SUMMARY NOTES OF THE AUGUST 7, 2013 MEETING OF THE ROOT RIVER WATERSHED RESTORATION PLAN ADVISORY GROUP

REVIEW OF PARTIAL PRELIMINARY DRAFT CHAPTER IV, “CHARACTERIZATION OF THE WATERSHED,” OF SEWRPC COMMUNITY ASSISTANCE PLANNING REPORT NO. 316 (CAPR NO. 316), “A RESTORATION PLAN FOR THE ROOT RIVER WATERSHED”

**REVIEW OF PARTIAL PRELIMINARY DRAFT CHAPTER V,
"DEVELOPMENT OF TARGETS AND ALTERNATIVE MEASURES,"
OF SEWRPC COMMUNITY ASSISTANCE PLANNING REPORT NO. 316
(CAPR NO. 316), "A RESTORATION PLAN FOR THE ROOT RIVER WATERSHED"**

Horlick Dam Alternatives

Map V-D

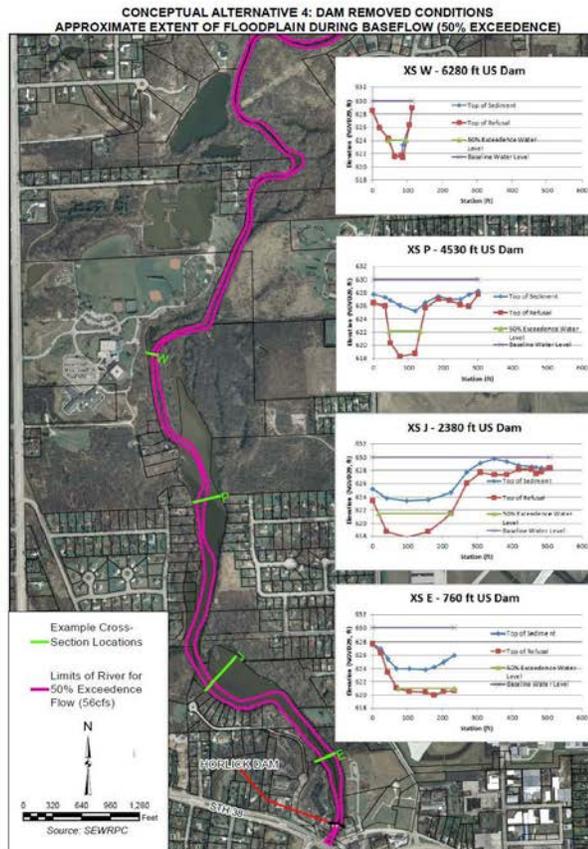
Mr. Osterman mentioned that the estimated extent of the River under conceptual Alternative 4 as shown on Figure V-D is considerably different than under the other alternatives. Ms. Kletti replied that the extent under alternatives 3 and 4 would be similar, but it is substantially less than under the other alternatives.

[Secretary's Note: Based on Mr. Osterman's comments and the discussion during an August 14, 2013, meeting with the Racine County Executive, which was attended by County staff, Ms. Greenfield, WDNR staff, and SEWRPC staff, Map V-D was revised to include two potential impoundment extents—one under Alternatives 1 and 3 and one under alternatives 3 and 4. The revised Map V-D is attached as Exhibit D. That version of the map was shown at the August 28 public meeting at River Bend Nature Center, during which Horlick dam issues were presented and discussed.]

Map V-D

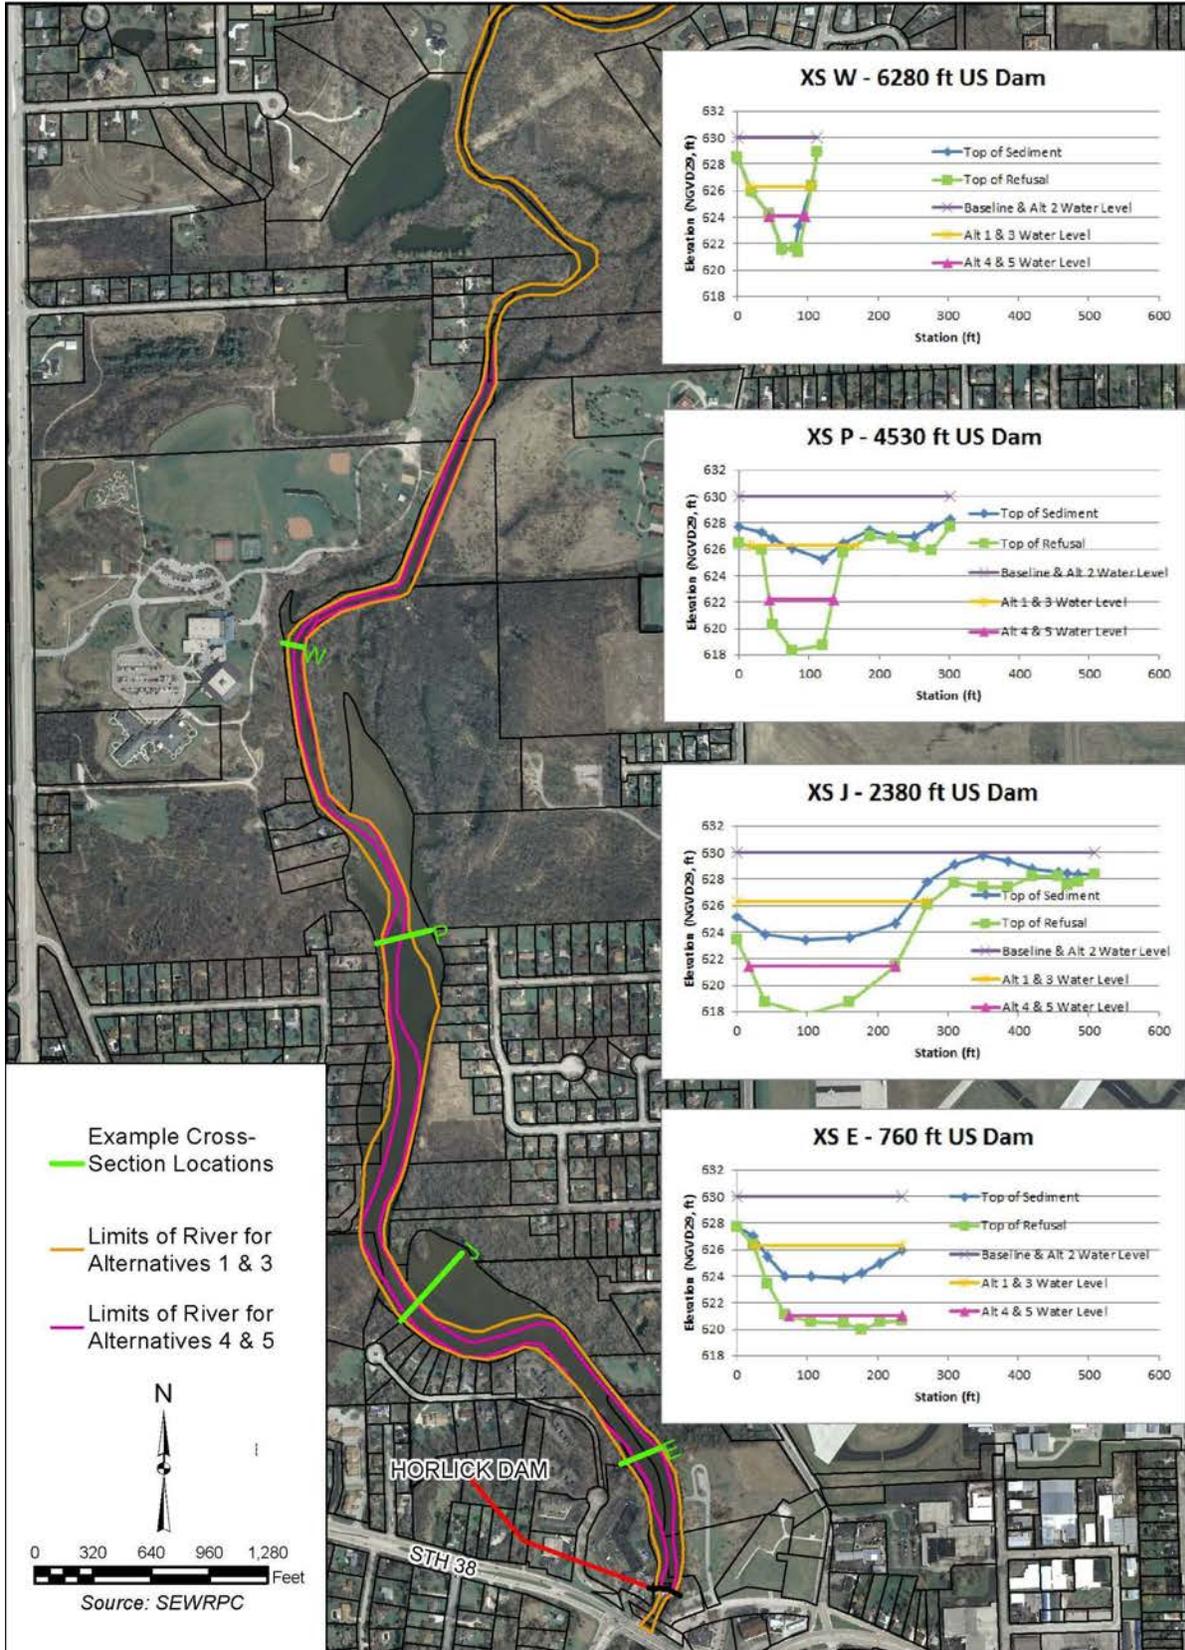
Mr. Martinka said that the extent of the impoundment under this condition would not look as shown on Figure V-D. Ms. Kletti responded that it was unclear what the extent of the impoundment immediately upstream of the dam would be because of the effect of the “ledge” in the streambed upstream of the dam.

[Secretary’s Note: Both Figures V-D and V-E (for Alternatives 3 and 4, respectively) indicate narrowing of the impoundment upstream of the dam site relative to Alternatives 1 and 2, and Figure V-E appropriately shows further narrowing relative to Figure V-D. Because of uncertainty regarding the degree of narrowing immediately upstream of the dam under the alternatives, no attempt will be made to revise conceptual Figures V-D and V-E.]

Map V-A
PRIVATE WELLS NEAR THE HORLICK
DAM IMPOUNDMENT CONSTRUCTED 1940-2010

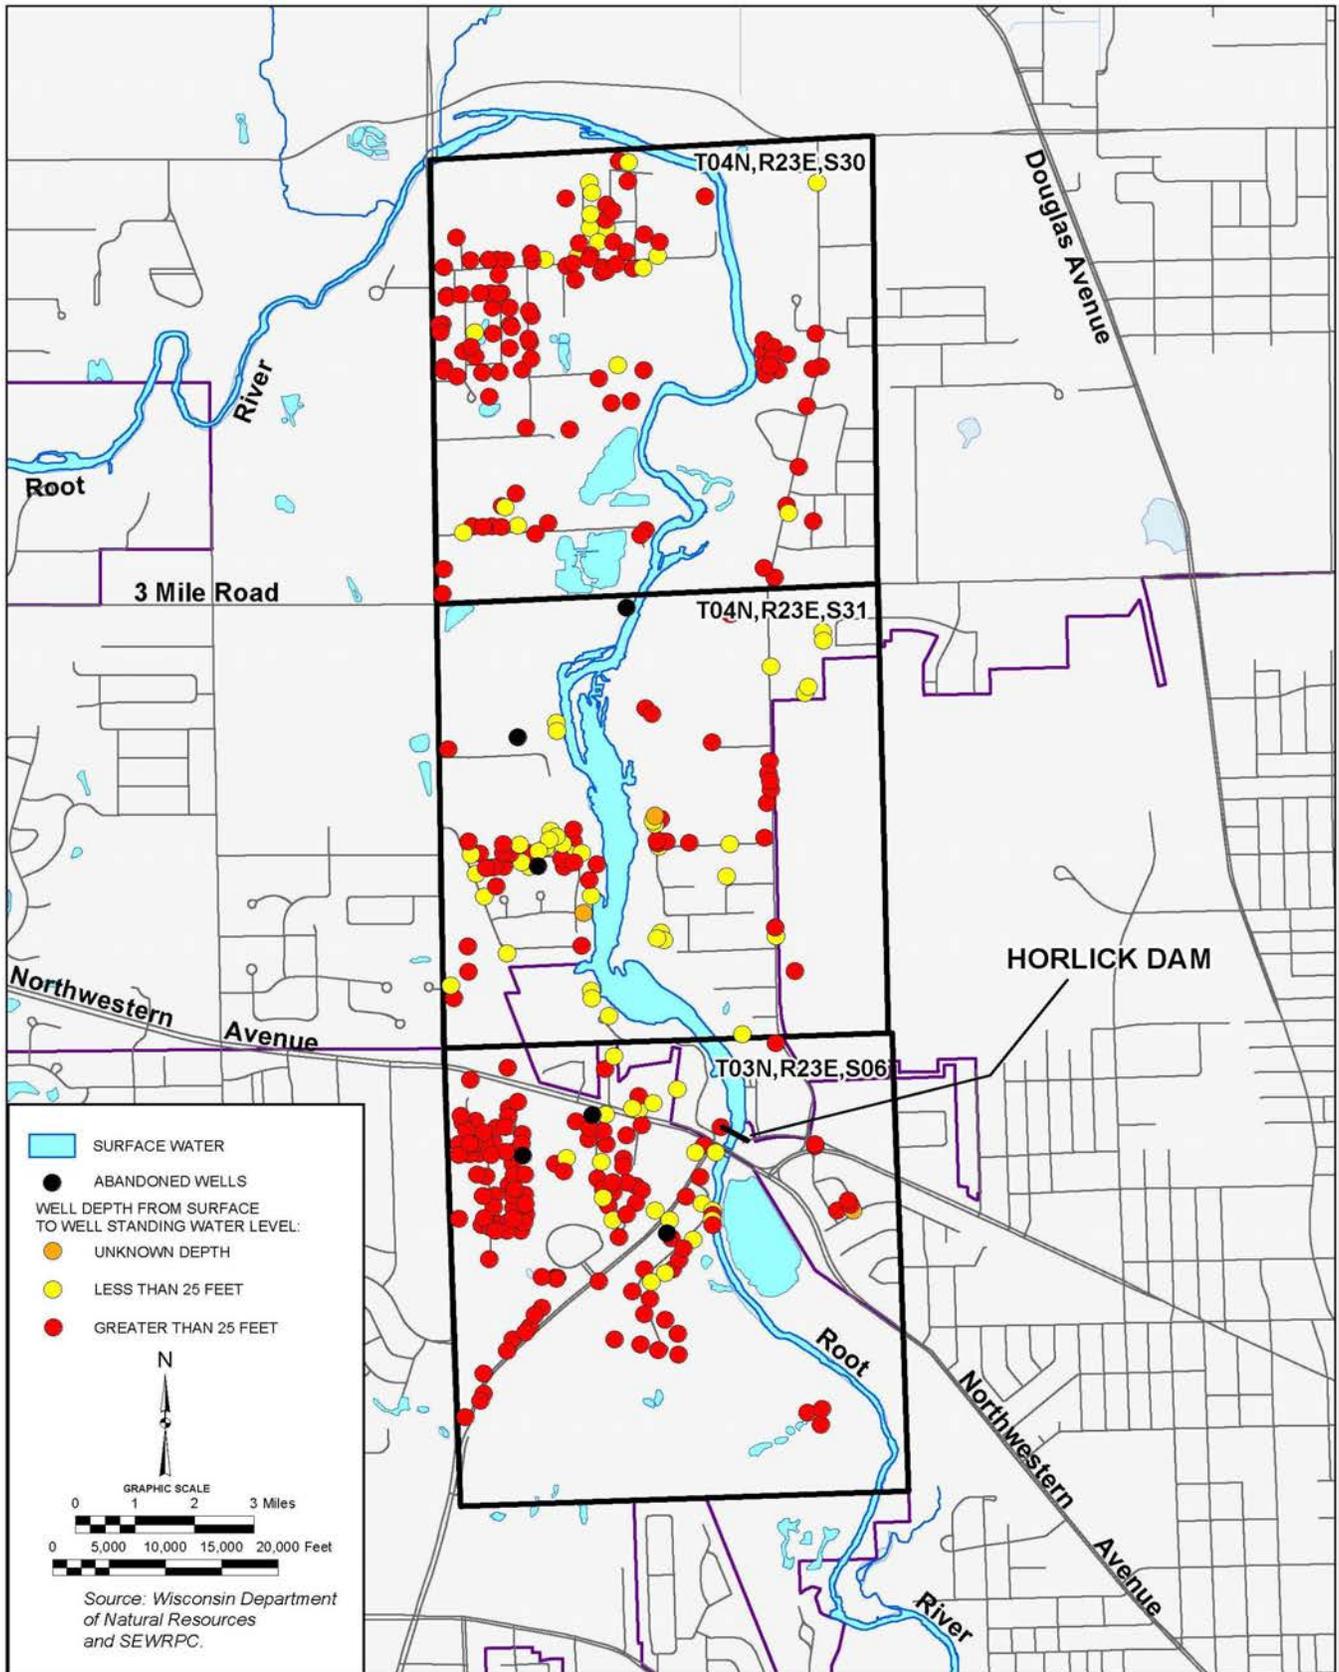
There was some discussion regarding Map V-A which shows locations of private wells in the vicinity of the Horlick dam impoundment. It was decided that the SEWRPC staff would check into municipal requirements regarding wells in existence prior to provision of a Lake Michigan water supply. Mr. Hahn noted that, while the possible effects on private wells of changes to the Horlick dam impoundment were noted in the draft report because such effects might be an issue that would be raised during the consideration of options for the dam, the significance of that issue should not be overstated.

[Secretary's Note: This issue will be investigated by the SEWRPC staff.]
